ADDENDUM #1

Reference: Parleys Maintenance Station #234 Improvements
Utah Department of Transportation - Utah
DFCM Project No. 08211900

DFCM Project No.: 08211900
Archiplex Group Project No.: 0728.02

ADDENDUM NO. 1 to the Contract Documents for the Construction of UDOT Maintenance Station #2434, Parleys Canyon, Utah.

A4 | ROOF DETAIL
AE503 | REF. AE312 | SCALE: 1" = 1'-0"

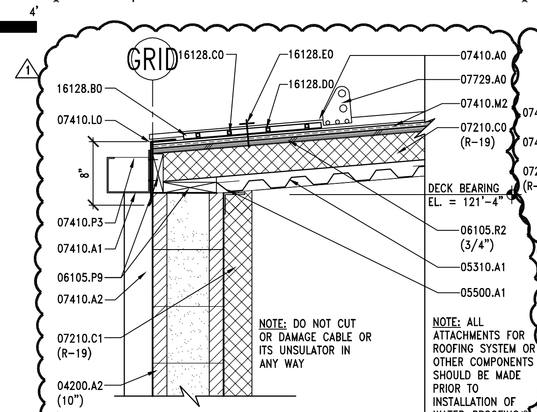
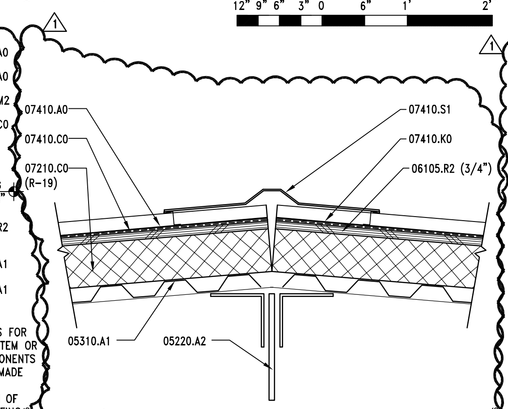
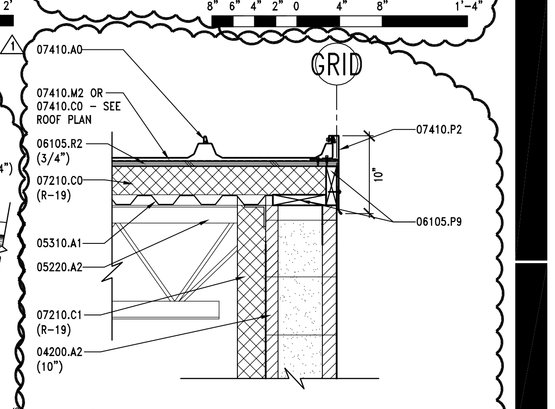
Sheet AE503:

a. Revised Details A4, A5, A6 & B6.
b. Revised Keynote Legend

TYPE WB

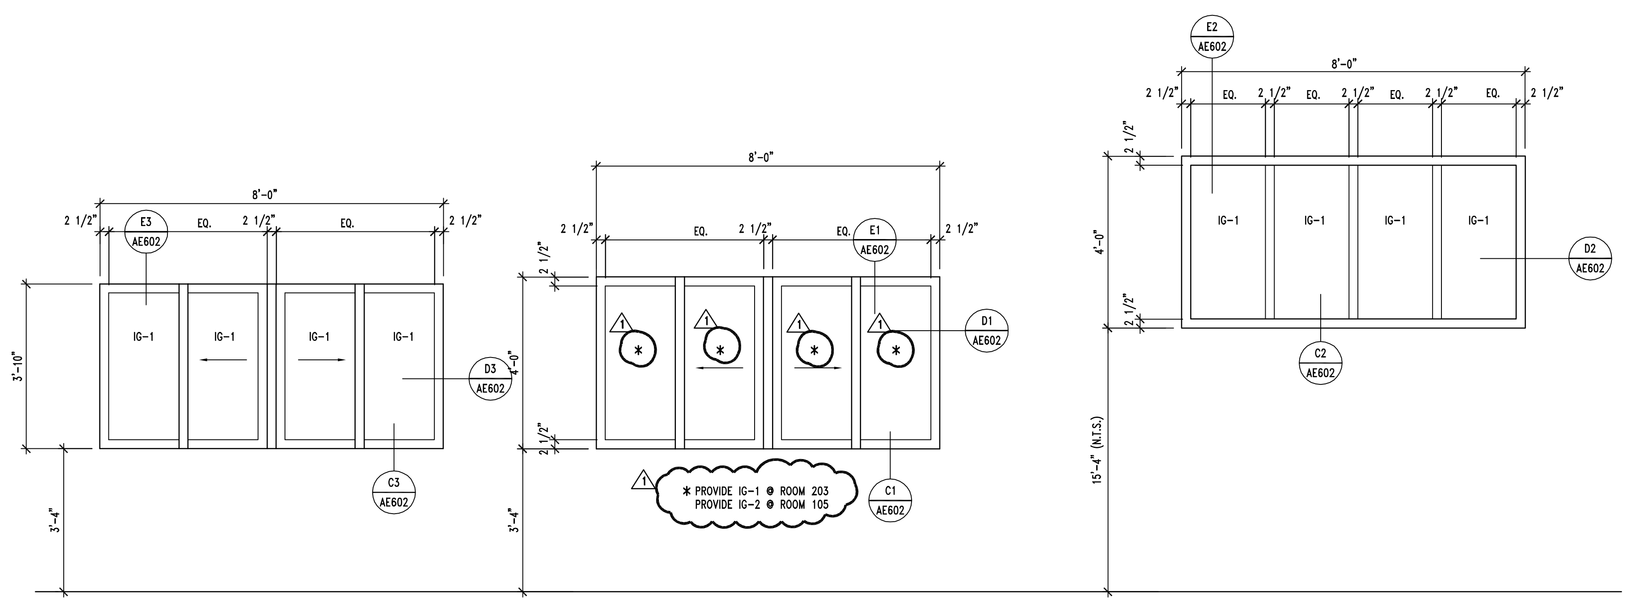
Sheet AE602:

a. Revised window type “WB” to provide tempered glazing at office window.

ROOF FRAMING PLAN

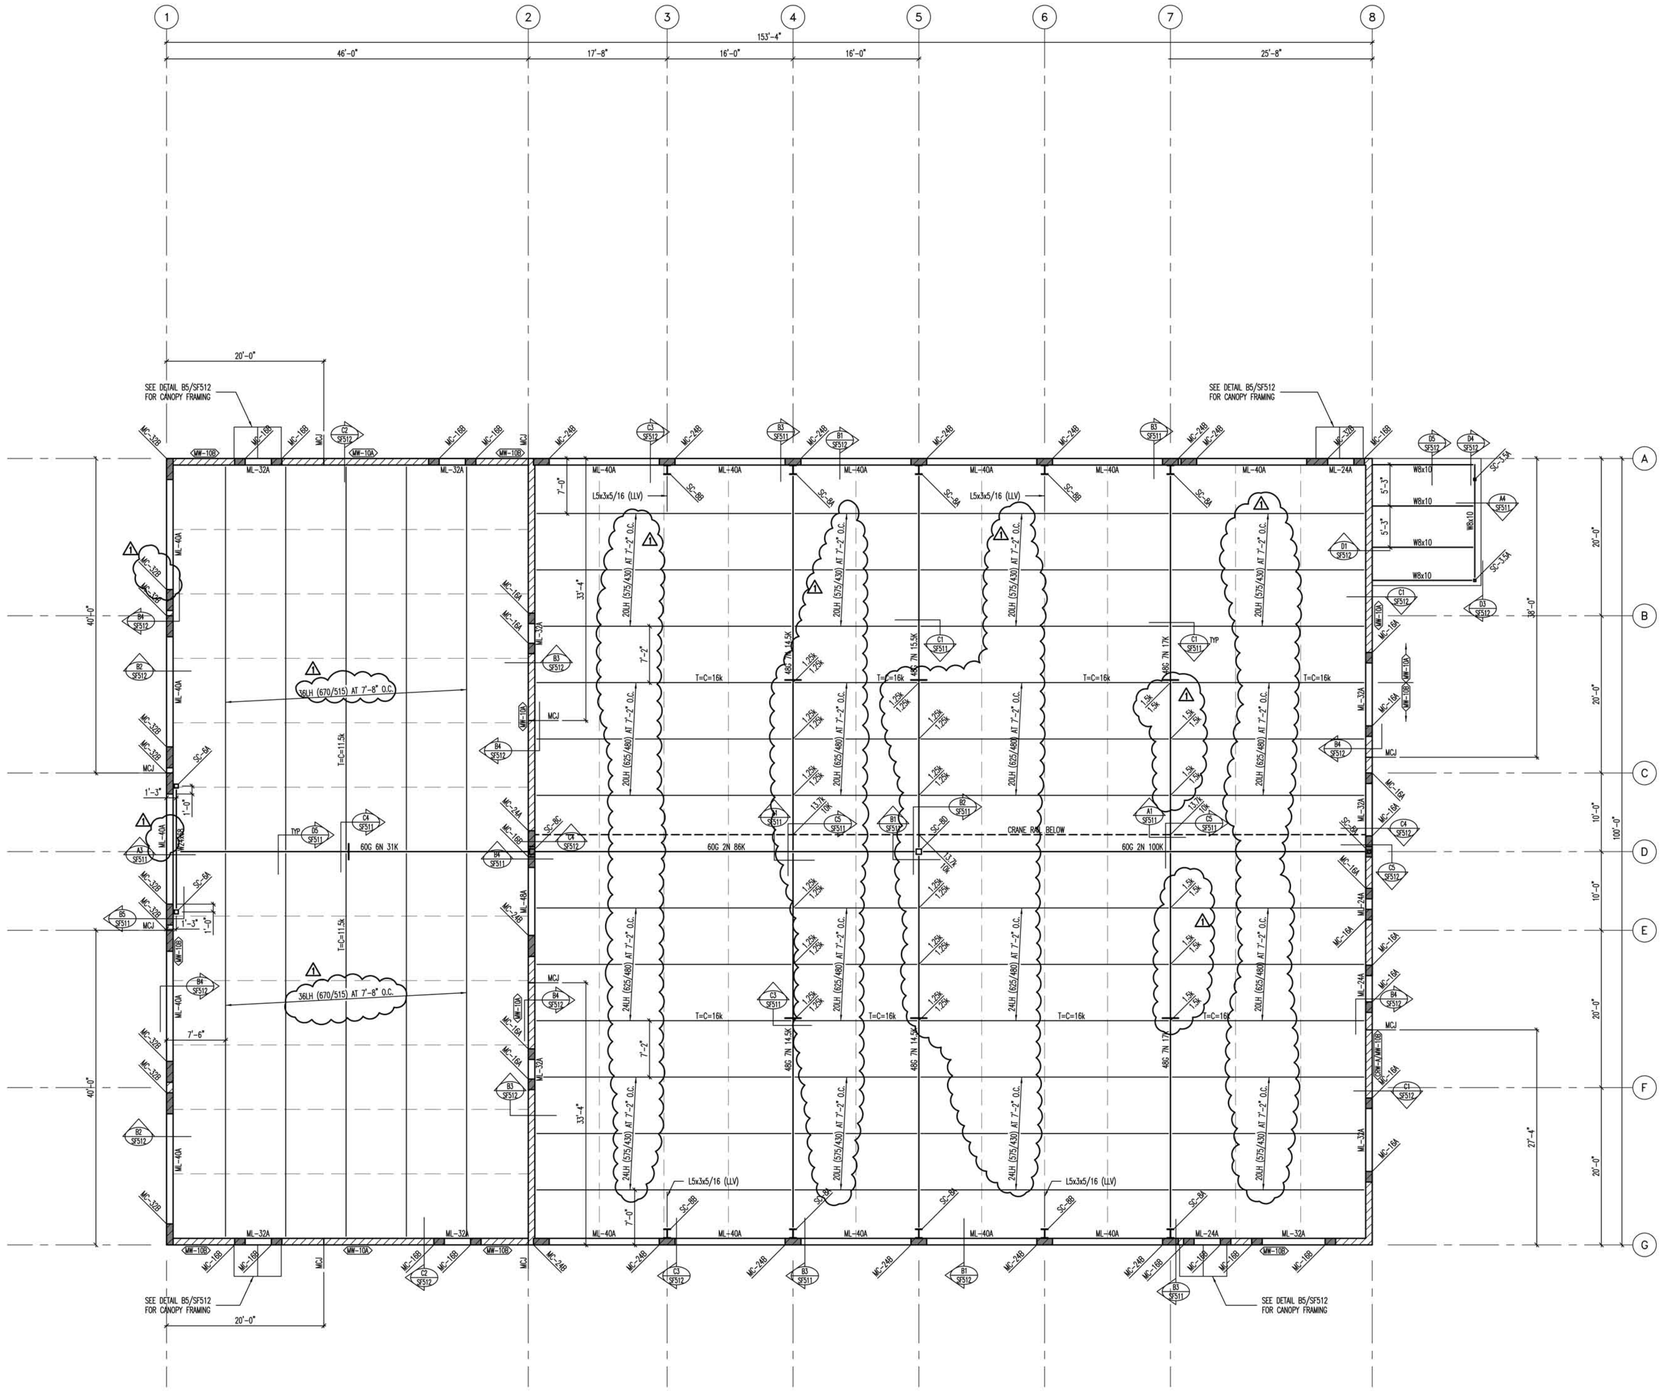
Sheet SF111:

a. Modified roof joist loads.
b. Modified masonry column and lintel grid 1.

(C2) MASONRY LINTEL SCHEDULE

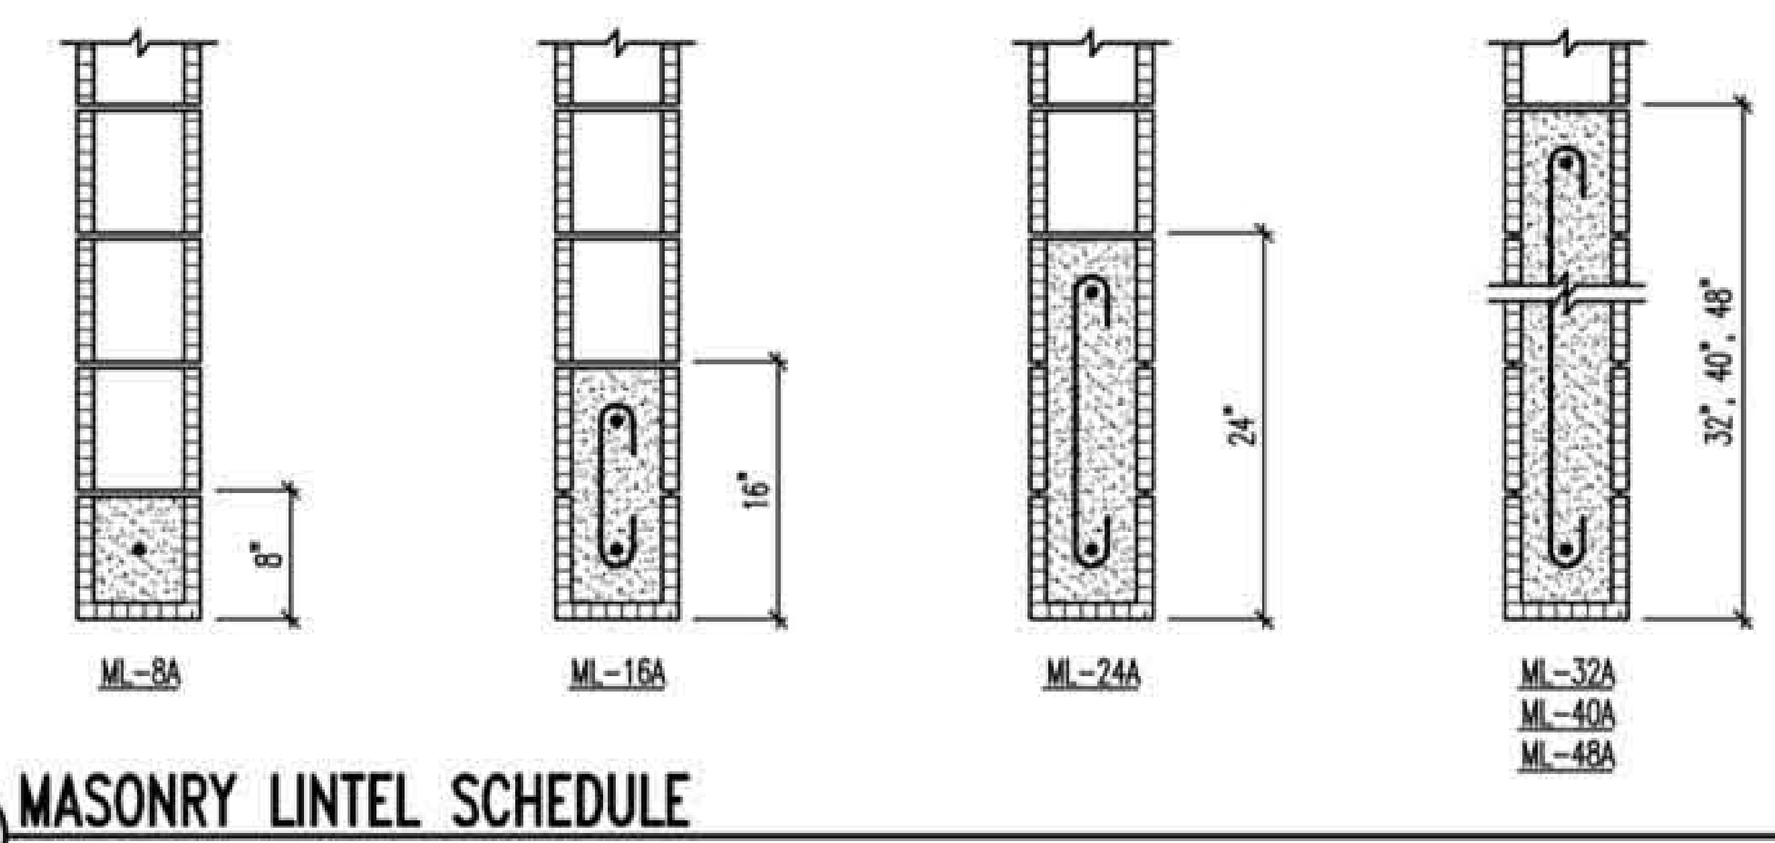
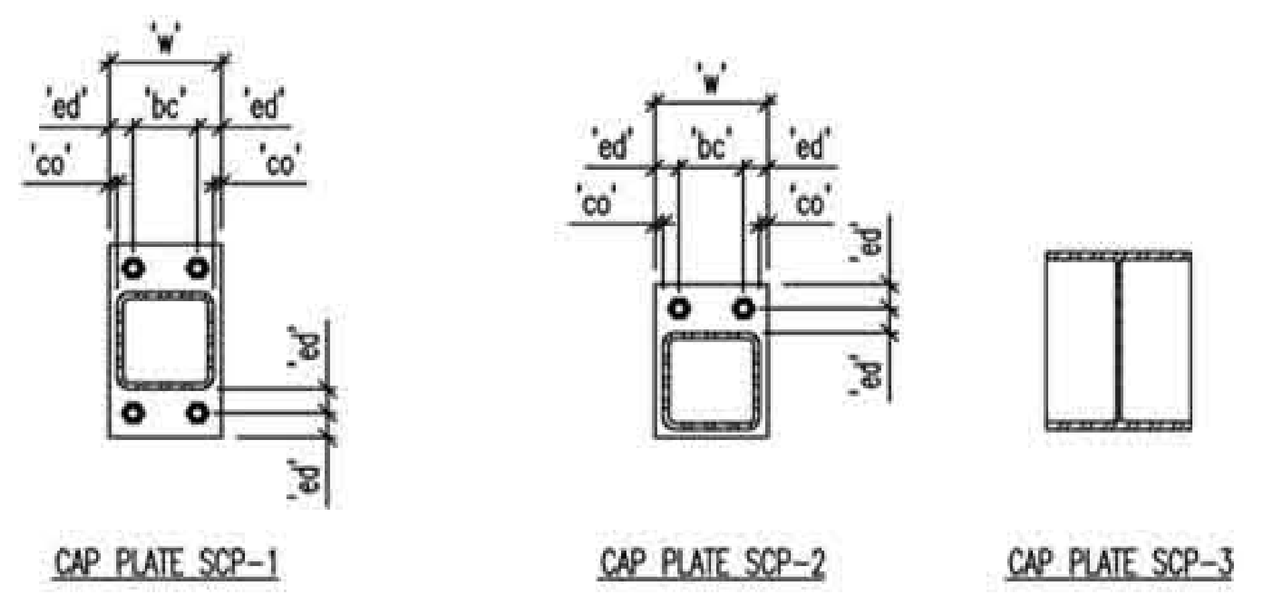
Sheet SF601:

a. Added ML-48a to schedule.
b. Clarified call out of MC-16a.

1 P201 **1st FLOOR PLUMBING PLAN**
SCALE: 1/8" = 1' – 0"

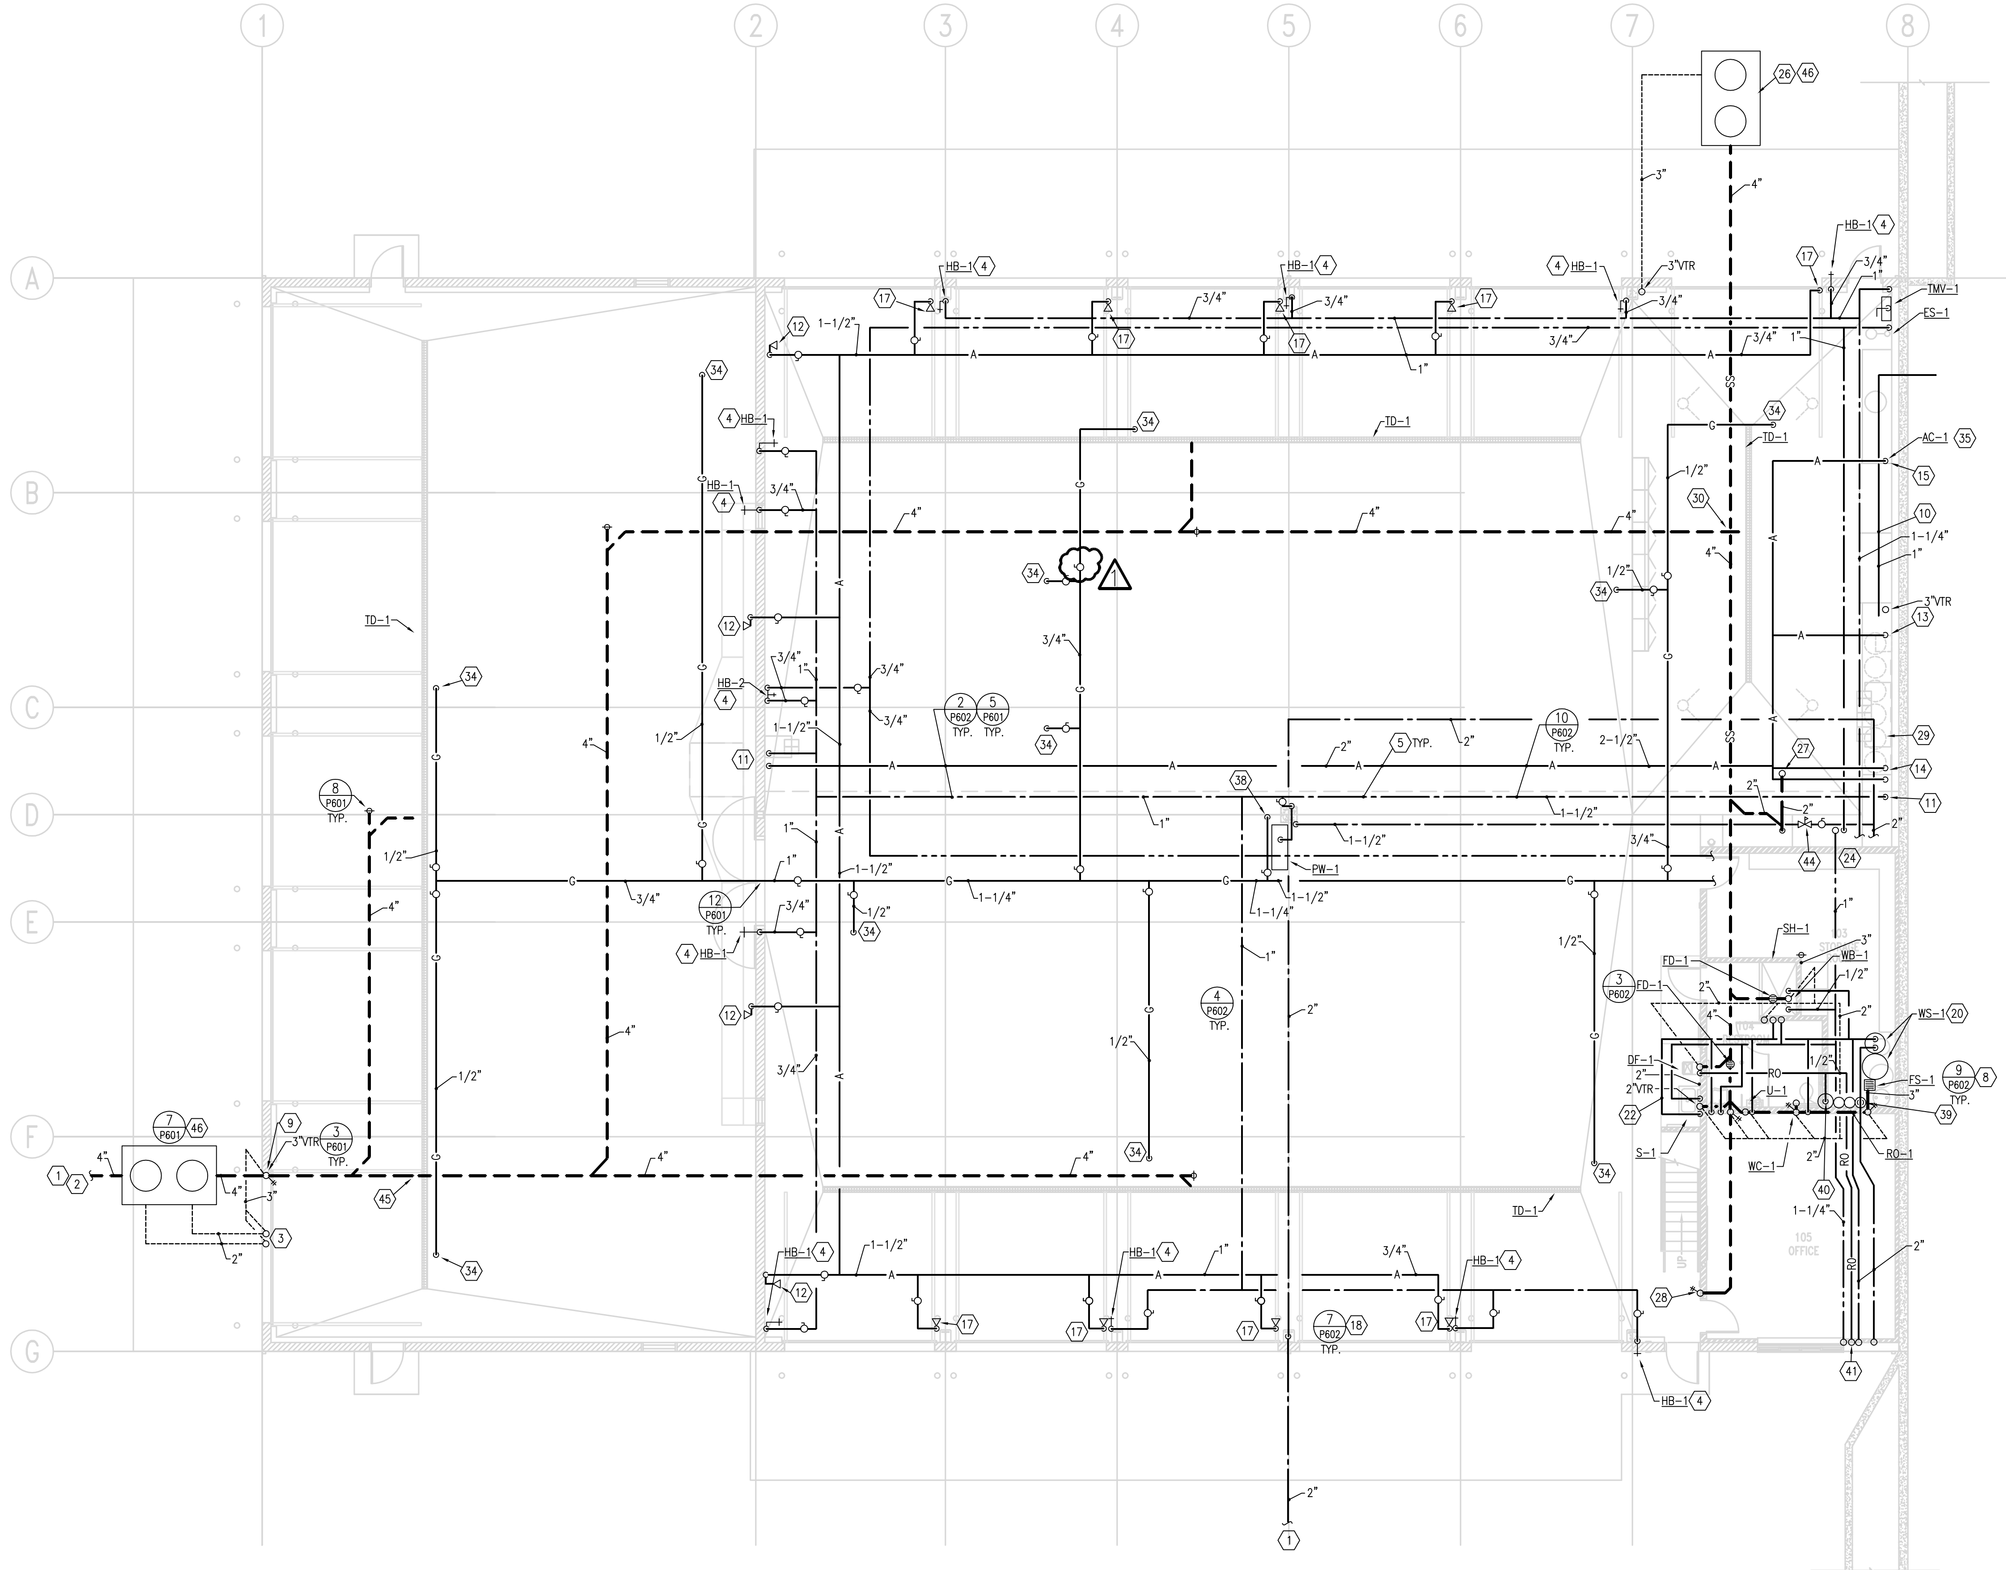
Sheet P201:

a. Revised note 26 to coordinate new holding tank size with Civil Drawings.

1 M301 **ISOMETRIC NATURAL GAS DIAGRAM**

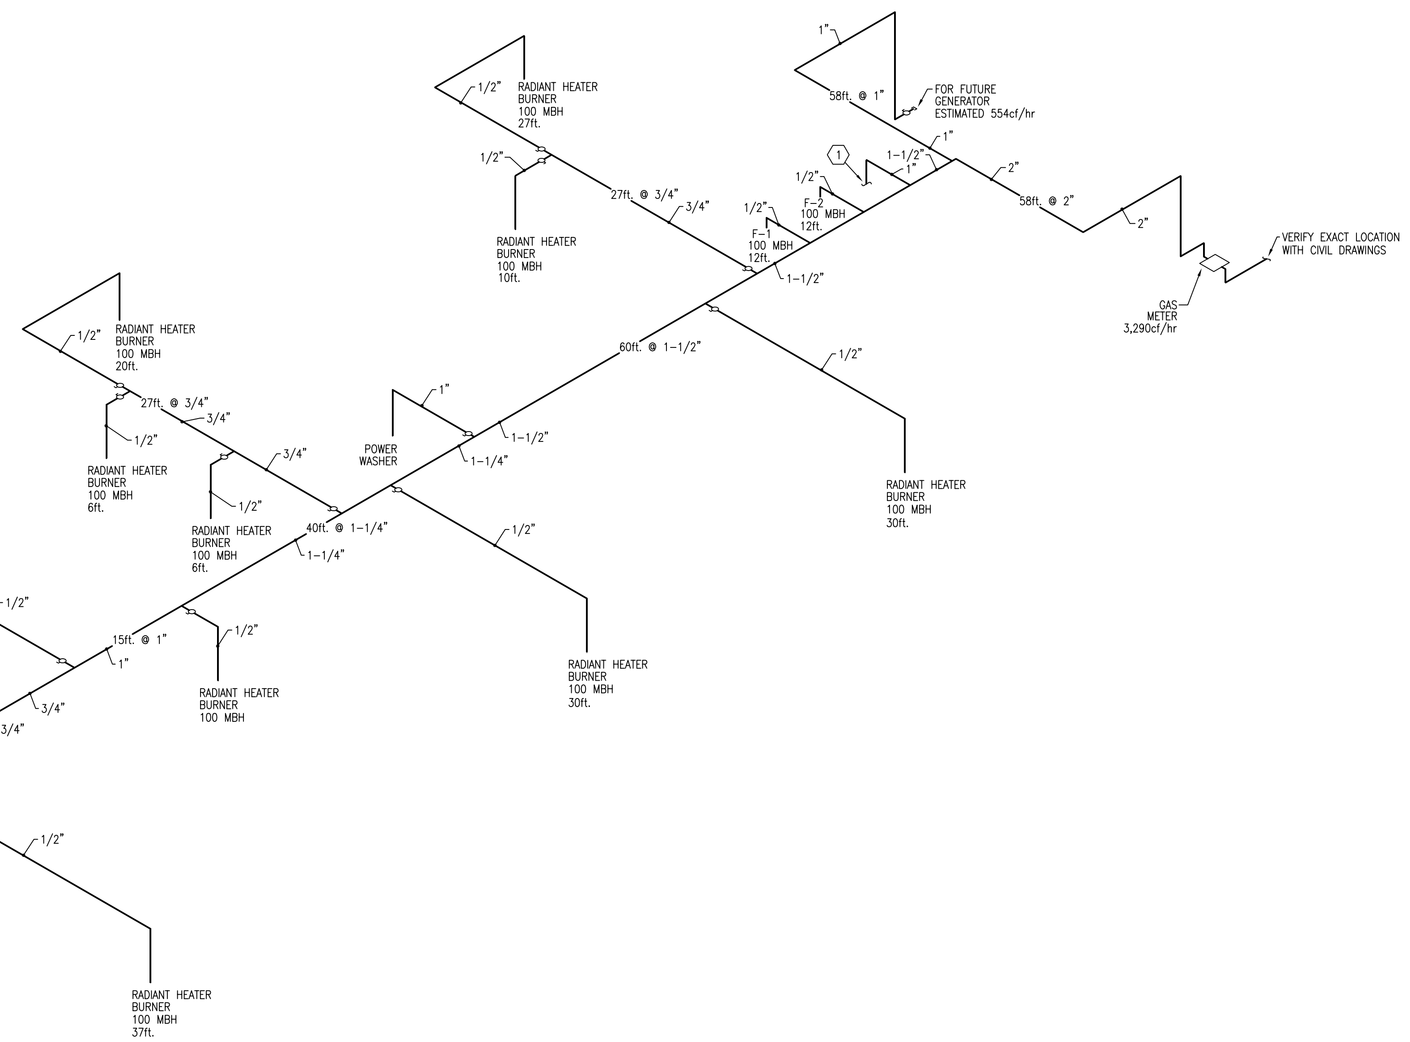
Sheet P301:

a. Added sheet to show Gas Line Isometric as requested by Code Official.
